Answers to Anonymous Referee #1 comments

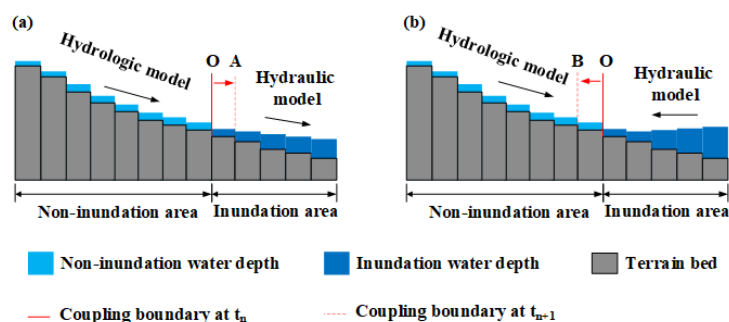
line 212, "is moved to point A", so where was it before?

This indicates the coupling boundary position at the present time step. For the first case, the coupling boundary position will moved to A in the next step, as shown in the following figure(a).

In the modified manuscript, the paragraph has been rewritten to make more clearly. See line 198~204.

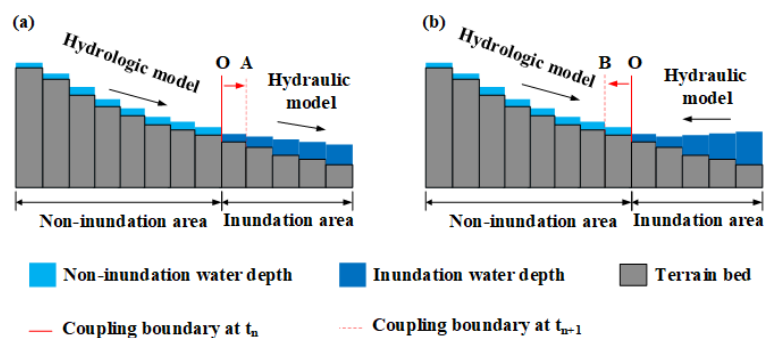
Figures 2 and 4, what is the colour code?

Figure 2 and Figure 4 will be merged into single one as follows: See Fig.3 in the modified manuscript.

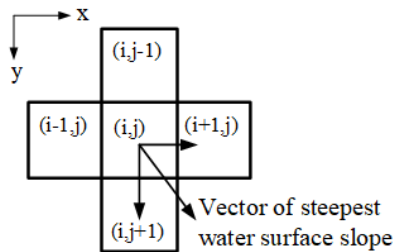
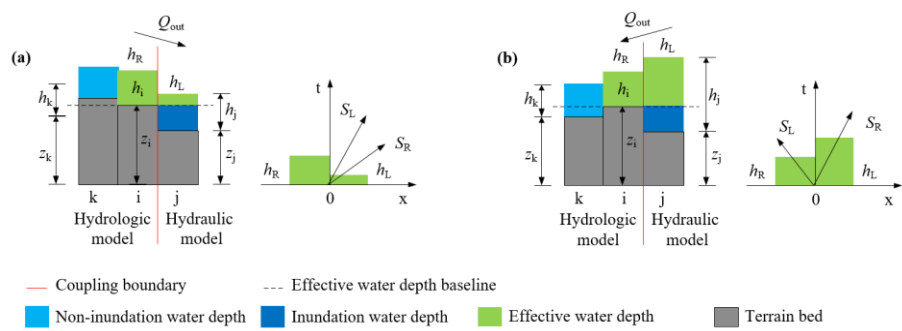
Figure 4, why water cannot flow to the left in the middle figure?

The effects of gravity are that the flow at any point will tend to be in the direction of the steepest water surface slope, as shown in the following figure:

For clarification, figure 4 (Figure 5 in the modified manuscript) was modified as following:
